Subject: AP1000 COL Response to Request for Additional Information (TR #03)

Revised Responses to Requests for Additional Information on Technical Report No. 03

AP1000 TECHNICAL REPORT REVIEW

Figure RAI-TR03-020-1 - Rev 4 SCV

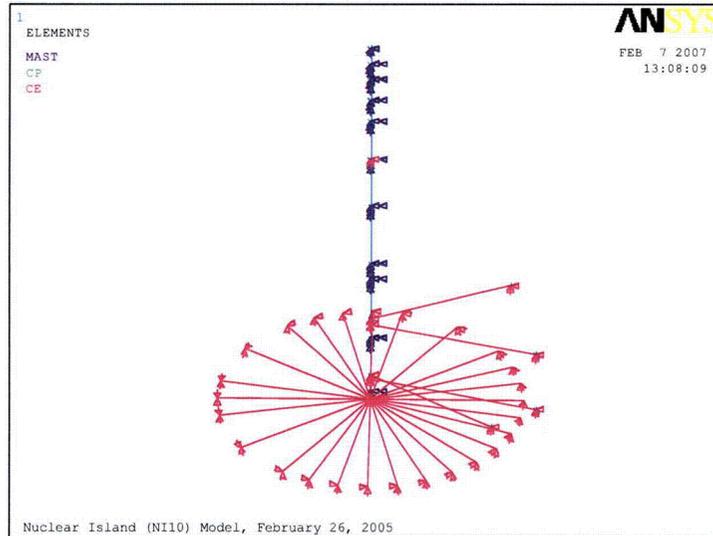
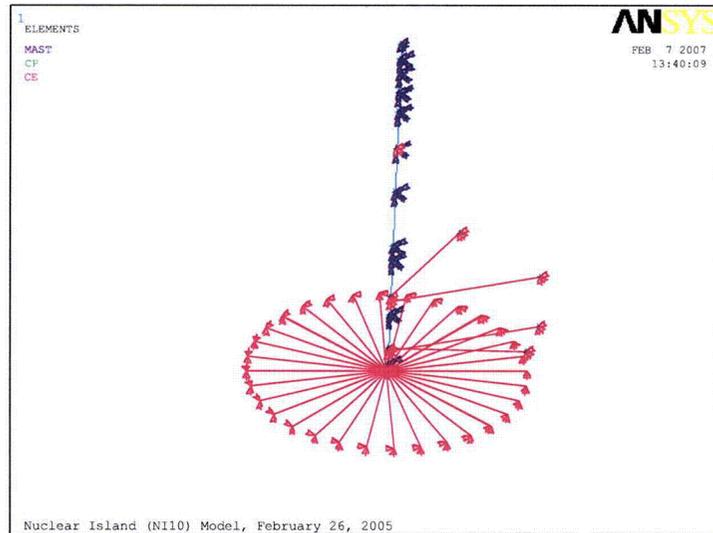
- a. Comparison of Figure 6.1-4 to Figure 6.1-6, and comparison of the stick model results to the FE model results at the top of the SCV in Figure 6.1-6, raises a question about the connectivity of the bottom of the SCV stick to the CIS FE model, at node 130401. The staff requests Westinghouse to provide a detailed technical explanation for the following:
 - a. Why is the x-direction spectral peak at node 130412 reduced by 1/3 (approx. 4.2 vs. 6.3), while the y-direction spectral peak at node 130412 is only reduced by 1/11 (approx. 6.6 vs. 7.2)? What mechanism has caused the ratio of y to x to change from 1.09 for the stick model to 1.57 for the FE model?
 - b. Why does the vertical spectrum comparison in Figure 6.1-6 show (1) an increase in spectral peak for the FE model, compared to the stick model, and (2) a significant shift in the frequency of the peak?

The connection of the bottom of the SCV stick to the CIS finite element model at node 130401 was reviewed. The connectivity, via constraint equations, is shown in Figure RAI-TR03-020-1. As seen the connectivity (identified as "Rev 4 model") is not symmetric around the SCV model. This connectivity was changed by adding six more connections so that it is symmetric. It is identified as "All Nodes" and is shown in Figure RAI-TR03-020-2. The vertical motion for the CIS interface nodes is tied rigidly to the vertical motion and rotation about the x-axis and y-axis of Node 130401 at the base of the SCV stick model. The tangential motion is tied rigidly to the horizontal motion and rotation about the z-axis of the same node. No constraints were placed for the radial direction of the CIS.

An additional case was considered that added constraints in the radial motion of the CIS to the SCV. This additional case is titled "Full Connection". The SCV bottom connectivity is the same as the "all nodes" case shown in Figure RAI-TR03-020-2.

Figure 7.2-3 Modeling of Actual Footprint in East-West Model

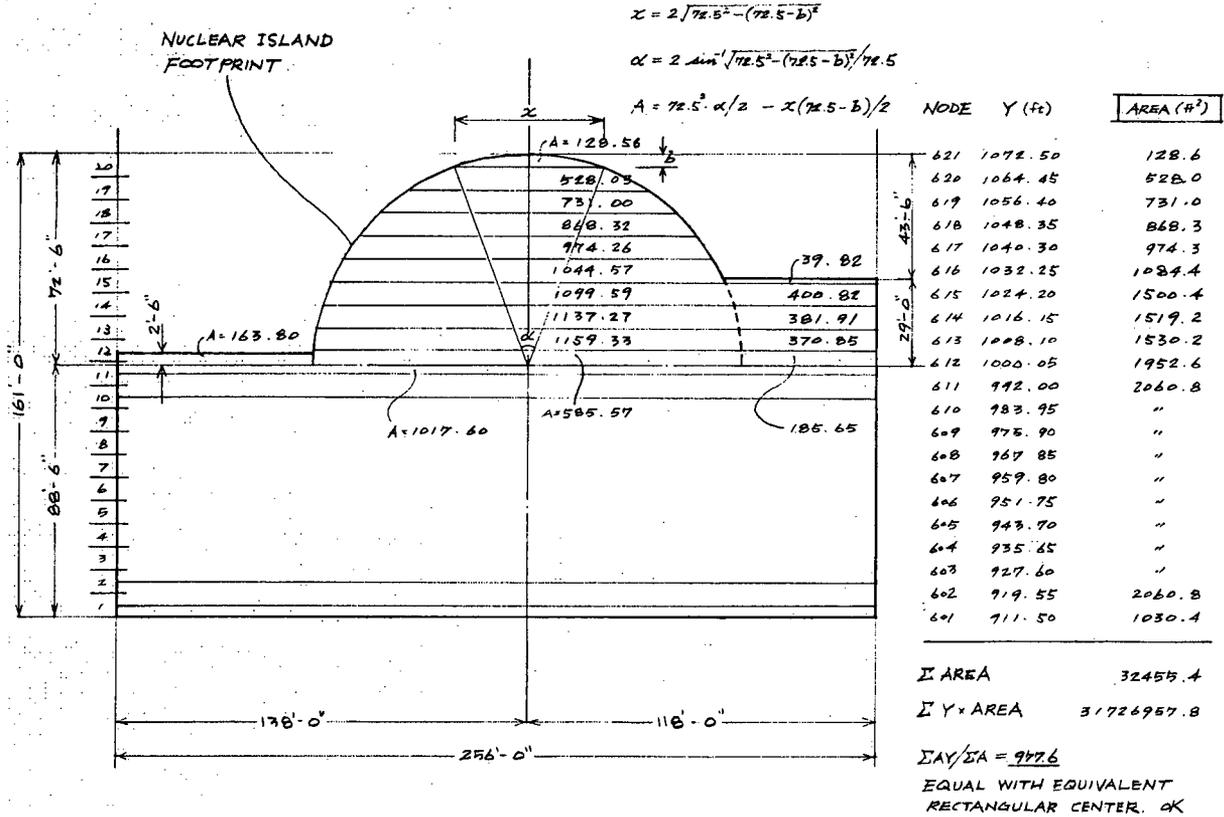
The description provided in Section 7.2 indicates that spring/dashpot values were selected based on parameters for a uniform half-space. However, for a soil site with hard rock located at a depth of 120 ft below the basemat, the resulting SSI radiation damping value would be expected to be significantly lower than that for a uniform half-space solution. Westinghouse should evaluate what is the impact of this difference on the computed seismic response?

The effect of liftoff during the safe shutdown earthquake of 0.3g and the review level earthquake of 0.5g was evaluated using the same approach described in section 7.1 for the hard rock site. The analyses used the East-West lumped-mass stick model of the nuclear island structures supported on a rigid basemat with nonlinear springs. The actual footprint of the basemat was used in these analyses of the East-West model (see Figure 7.2-3).

Figure RAI-TR03-032-1 - CIS at Reactor Vessel Support Elevation

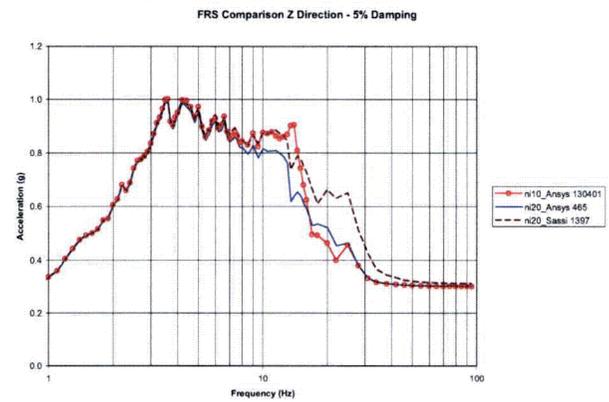
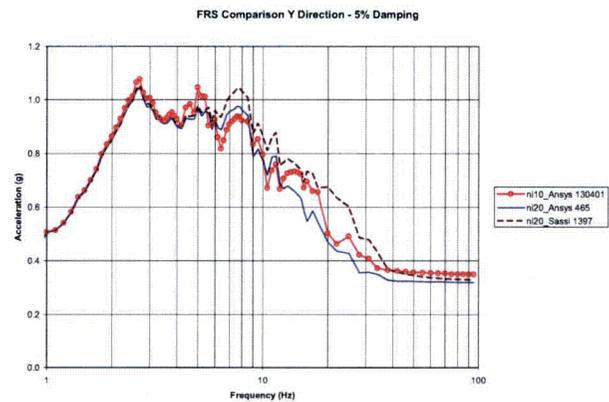
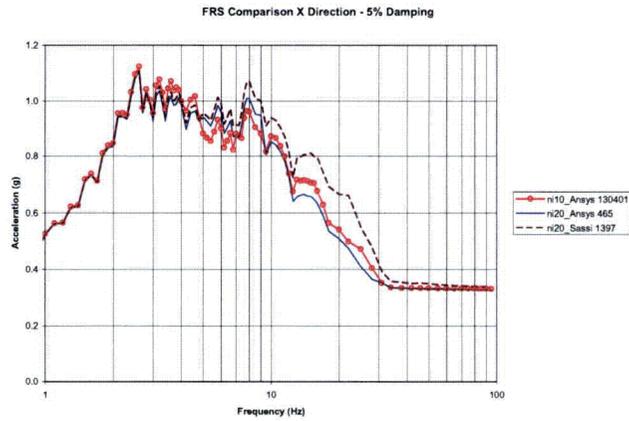
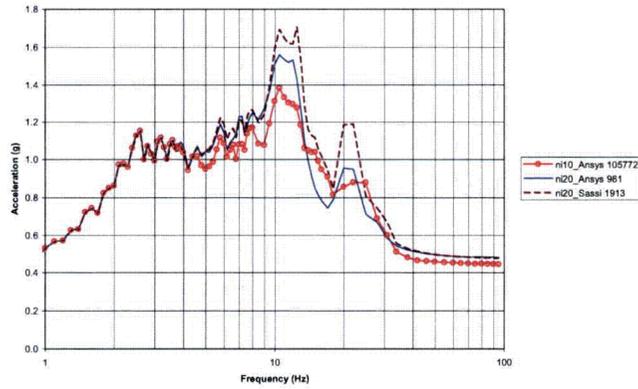
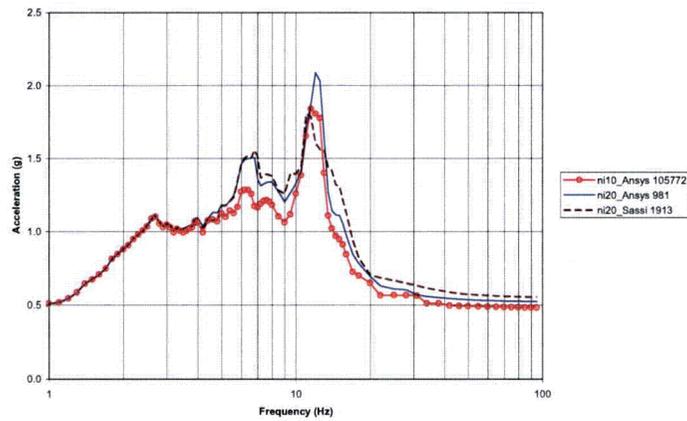
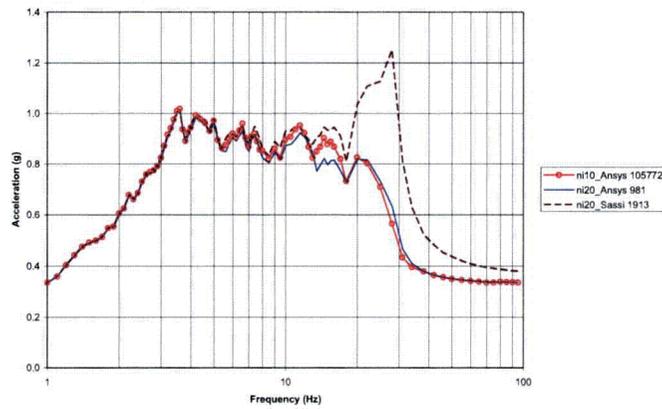
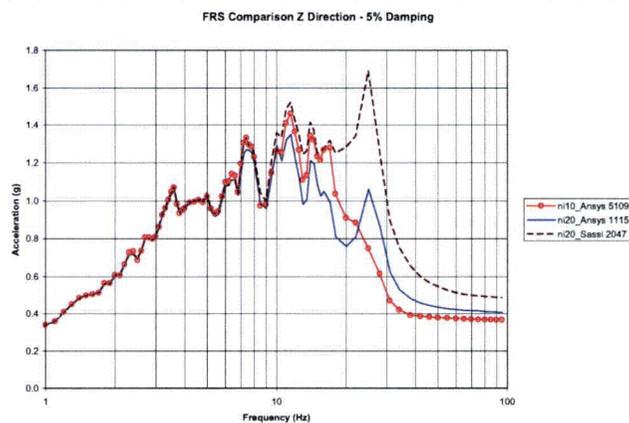
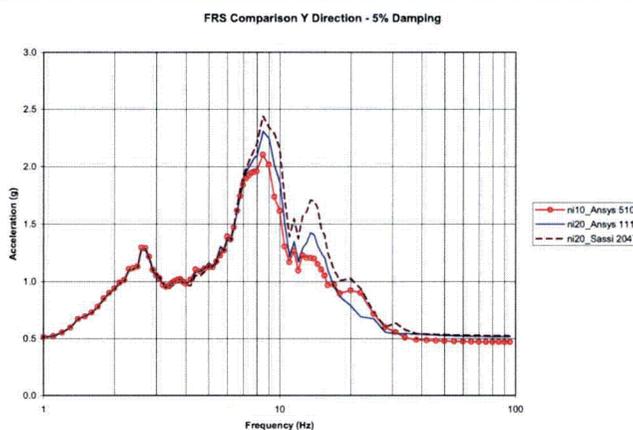
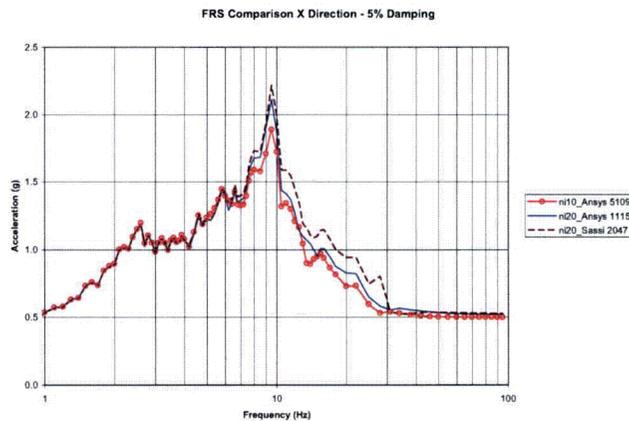
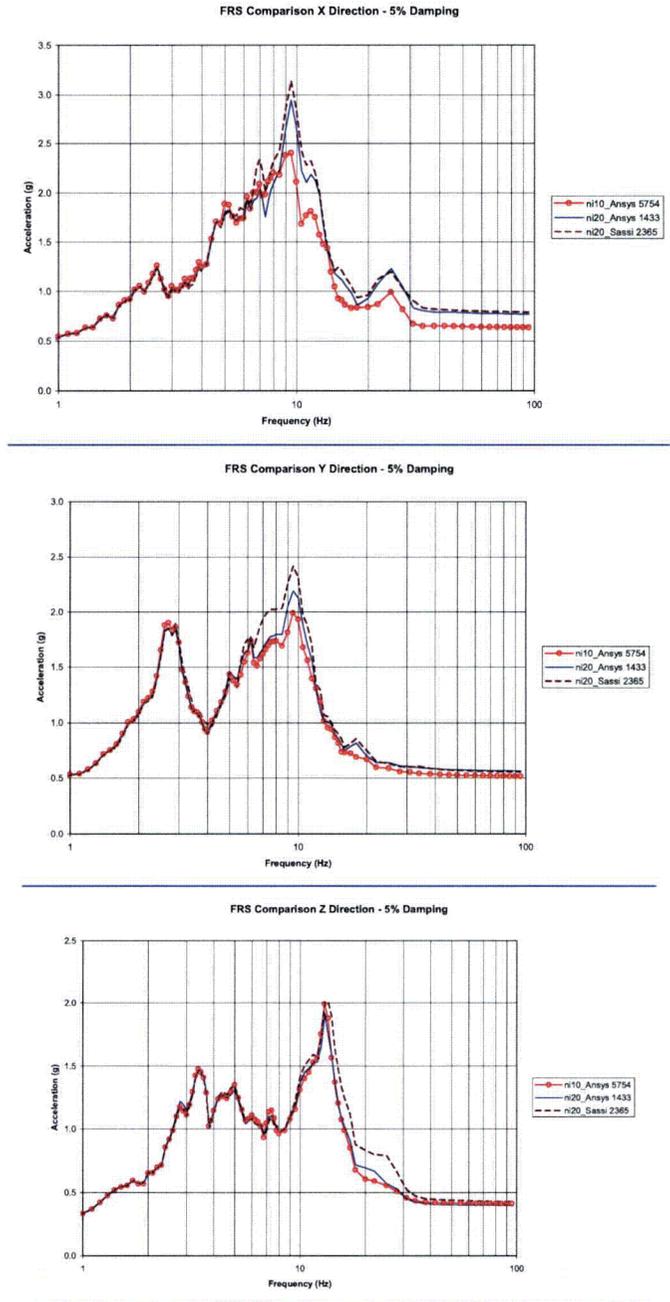
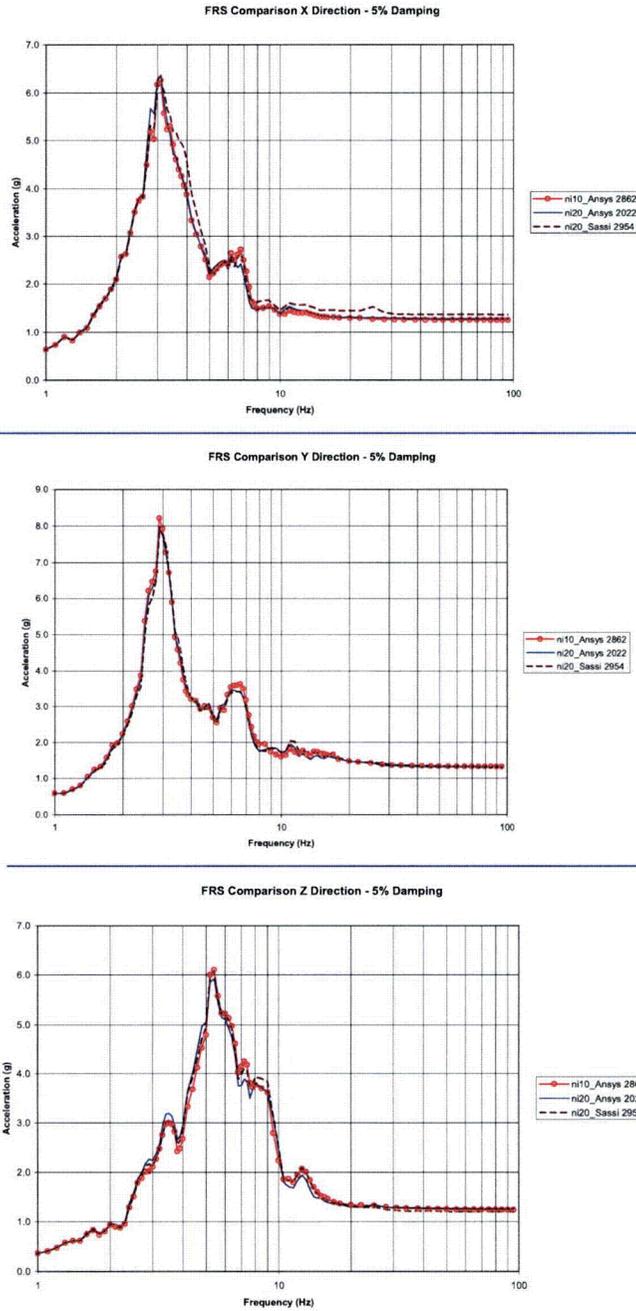
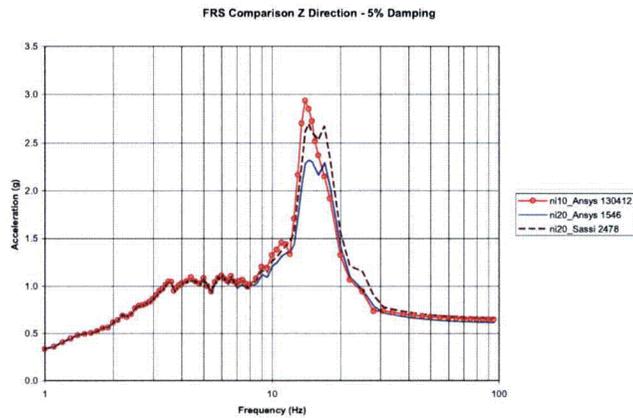
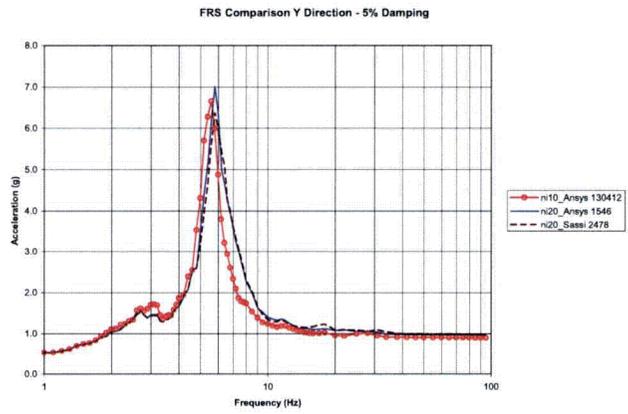
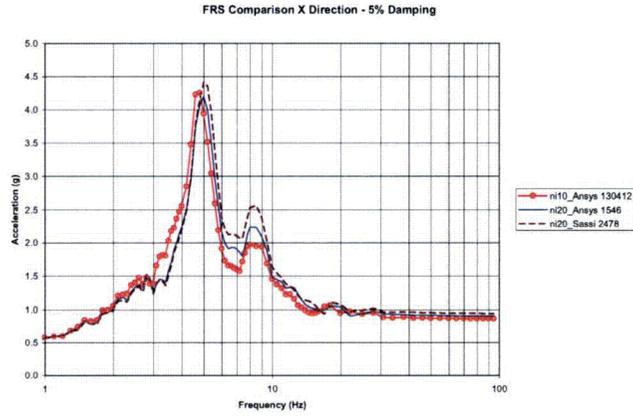
- c. Explain what studies were performed to establish that the NI10 model refinement is sufficient to accurately account for high frequency response effects at all critical locations. It is not obvious from the results shown in Figure C-1 that convergence with element size has been achieved.

The comparisons of the NI10 and NI20 results in Figures C-1 to C-6 show the NI20 model is acceptable for responses above 10 hertz. However, as stated in paragraph 2, the NI10 model gives more accurate results and is used in the fixed base analyses for hard rock. The comparisons of NI10 to NI20 were performed in ANSYS. Analyses have not been performed in SASSI with more refined models than the NI20 model.

- c) The NI10 model is described in DCD subsection 3.7.2 (Item 5) and is the basis for the vertical floor response spectra for hard rock. The model was reviewed and accepted as part of the hard rock design certification. During development of the model detail studies with greater element refinement were performed for the floor above the control room and the adjacent bays to confirm the adequacy of the model.
